FCC Class II Permissive Change for FCC ID:2AMFBLR3N

Senceive wishes to have a Class II Permissive Change for module FCC ID:2AMFBLR3N to add a new antenna to the filing:

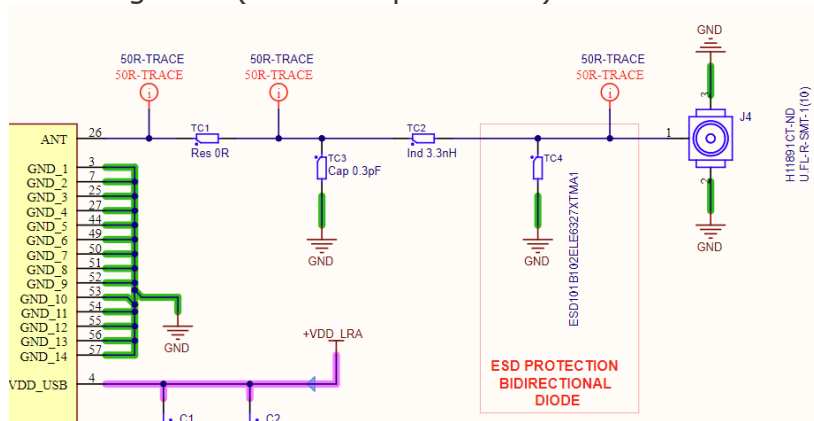
- Senceive do not sell the module to 3rd parties but install the module in their products only.
- The devices are professionally installed – please see exhibit “Antenna professional installation” for more detail.
- The certified module has been installed in a new host board, the L3N1 PCB.
- The antenna trace is connected to the SMA connector via a 50 ohm trace and matching filter (with ESD protection):
